DETAILED CONSERVATION COMMISSION AGENDA

Date: Thursday, November 18, 2021

1. (7:00) 5 Harwich Road – NOI – Addition to a single family home and deck – DEP #239-???

2 (7:30) 100 Boulder Road – NOI – tear down/rebuild single family home DEP file #239-???

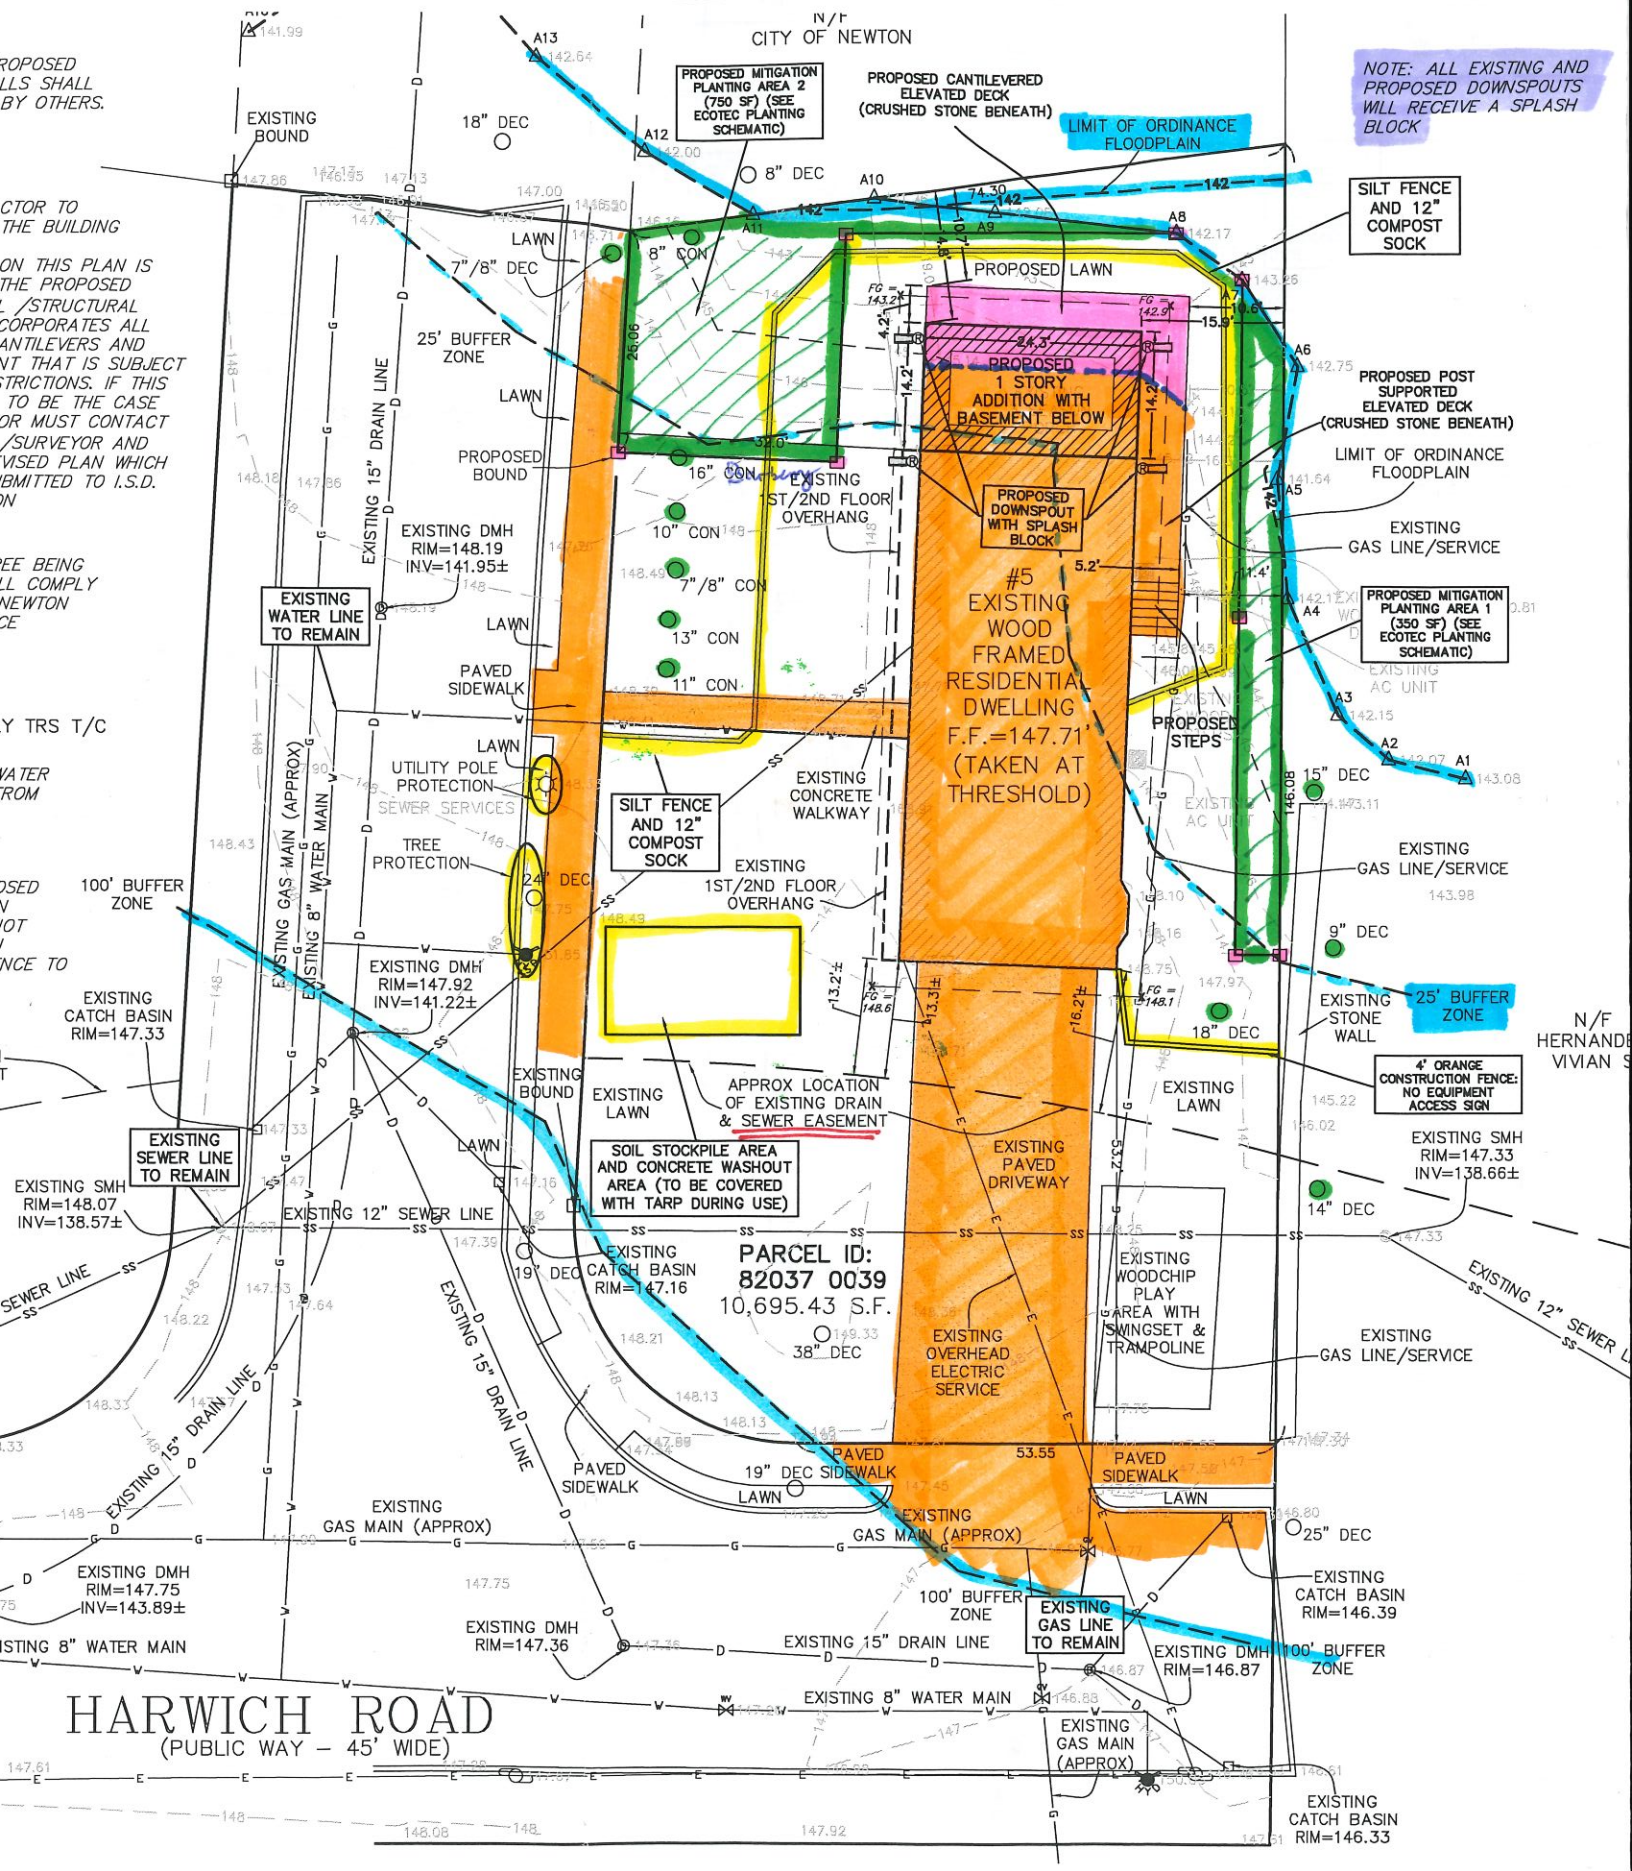
- Impervious area will be increased by 244 sf.
- No trees will be removed.
- Concrete washout will be accommodated on site.
- Staff Notes:
 - The plans lack a north arrow and dated signatures.

- Staff do not feel that the grading as shown on the surveyed plan is accurate in the northeast corner. The 142' contour and 143' contour lines do not seem to comport with the LIDAR topo on the City's GIS or staff's experience at the site. The discrepancy, however, is outside the area of proposed work.

- The plan indicates stockpiling and concrete washout in the same location. They should be separated since they may occur simultaneously.
 - A dewatering plan must be submitted for review and approval.

- Staff note that the full basement addition will likely be in groundwater.
 - The proposed work meets the "performance standard" for work in the 100-foot Buffer Zone

- A dewatering plan must be submitted for review and approval.

GRADING, DRAINAGE AND UTILITY PLAN

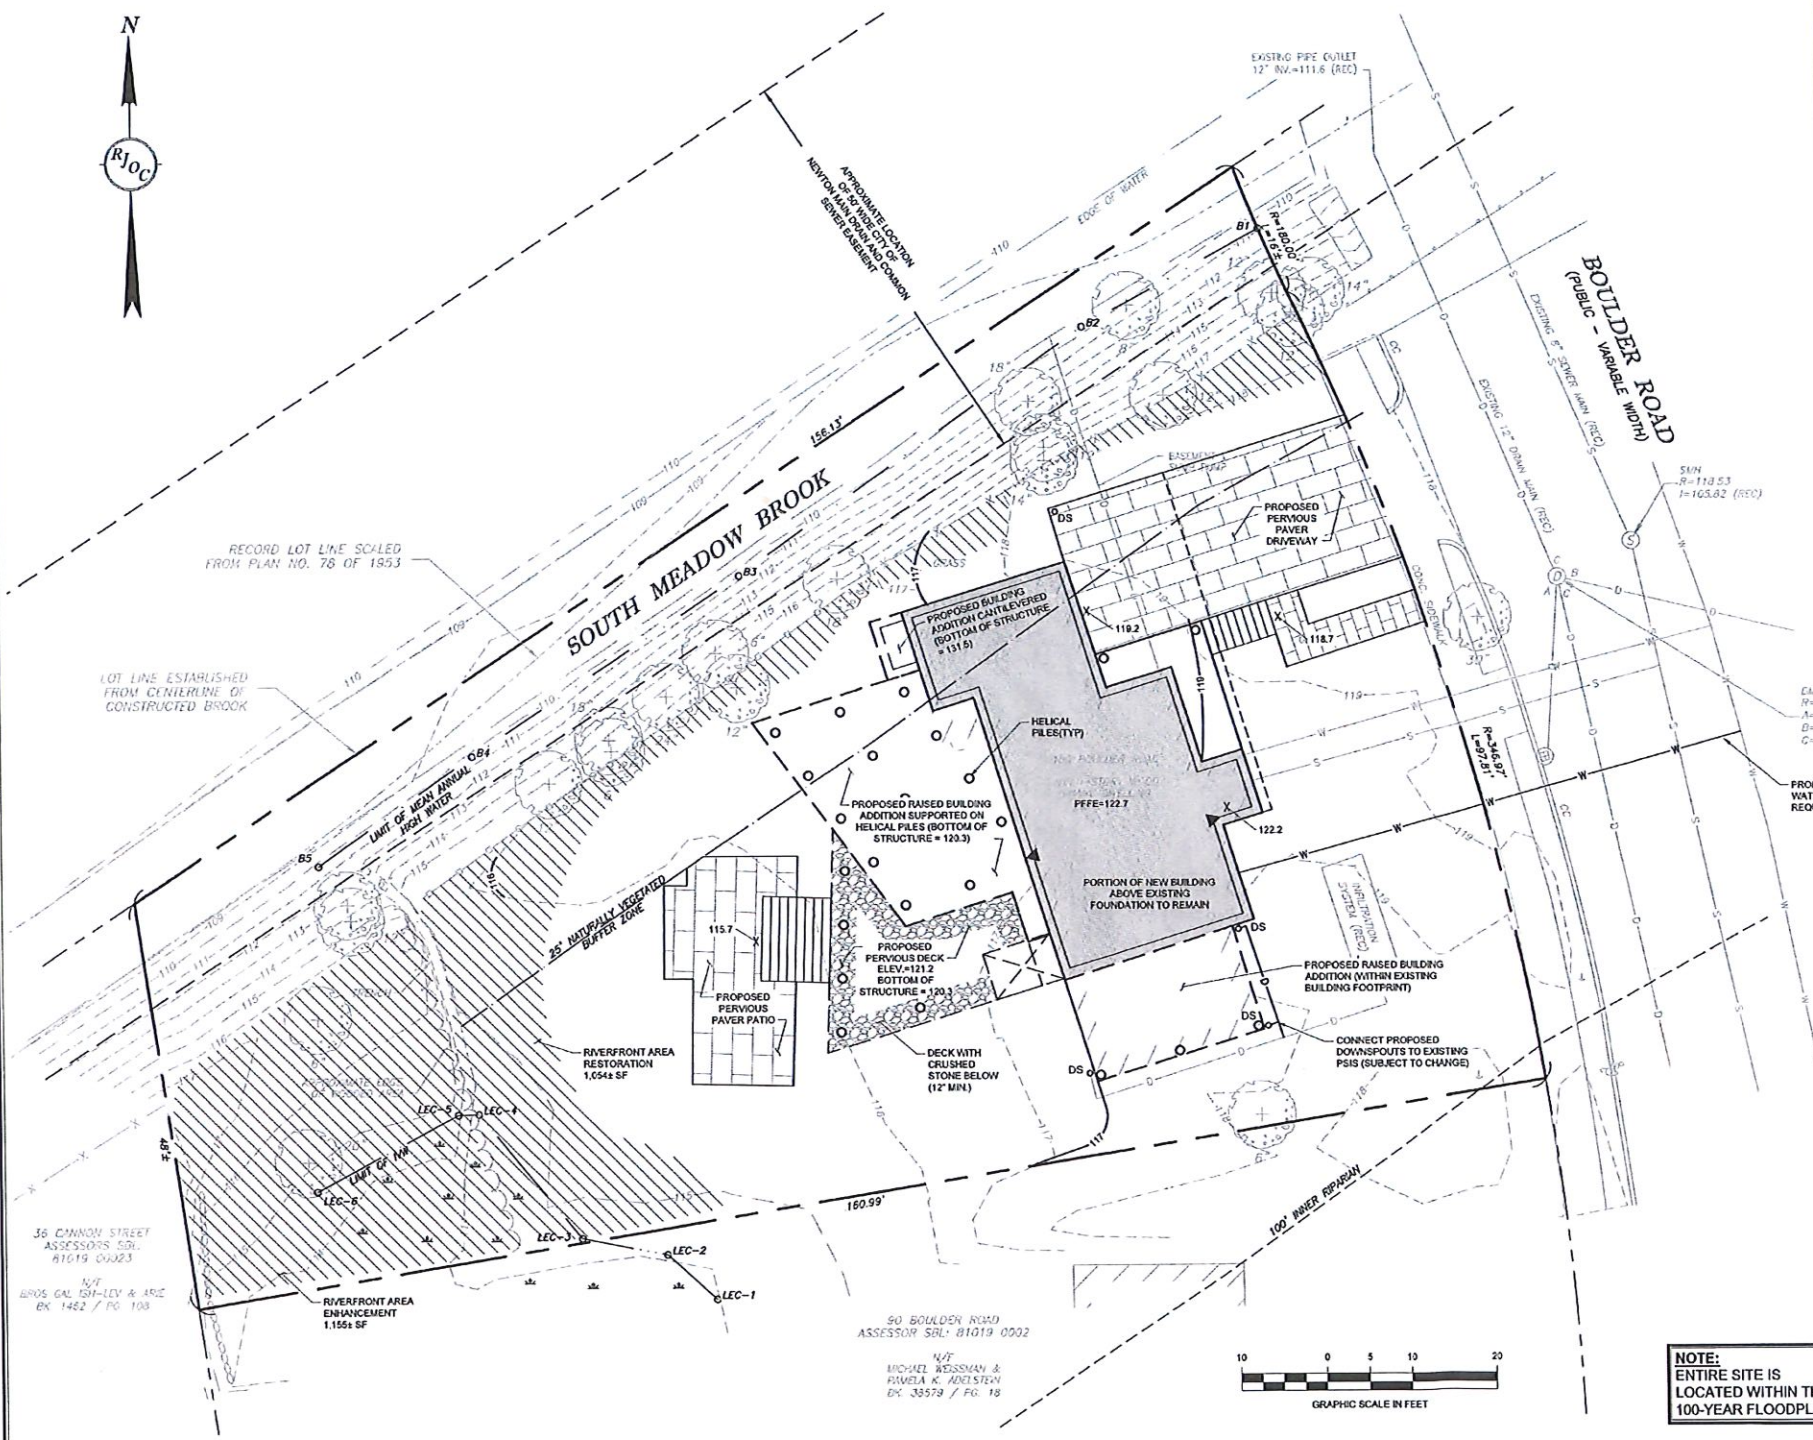
- New Granite curbing will be required along the property frontage
 - Property line bearings should be included on the plans
 - Both the existing water and sewer services will have to be upgraded. The plan should show the installation of both water and sewer services to the home.

LAYOUT, DEMO AND EROSION CONTROL PLAN

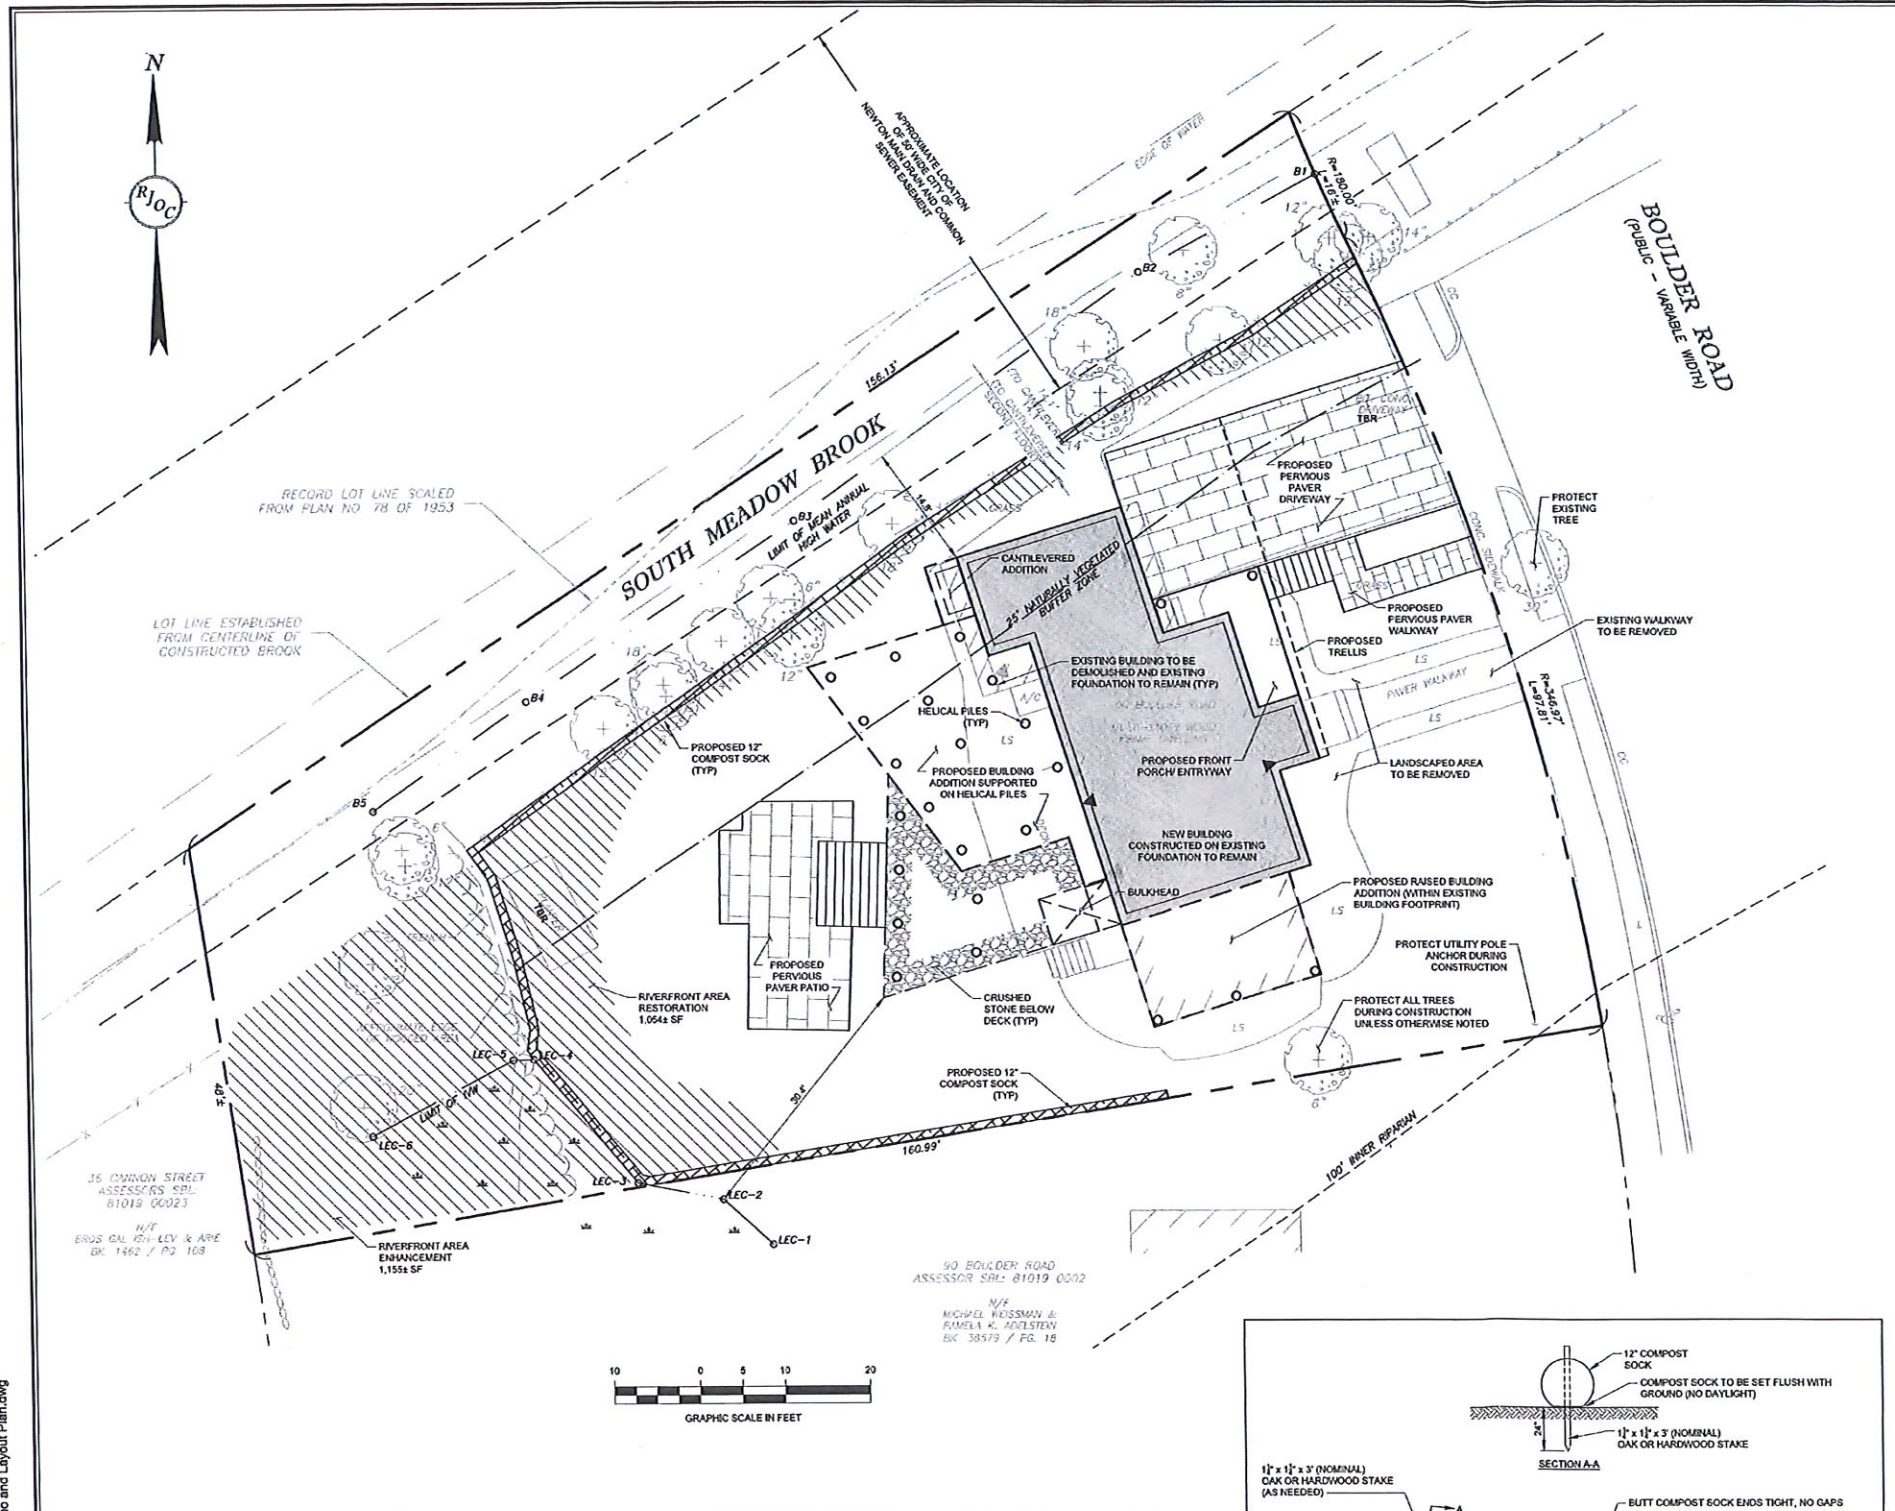
- The planting schedule does not include any canopy trees.
- Staff note that there is no area identified for laydown or stockpiling on the plans.
- Engineering’s preliminary review noted:
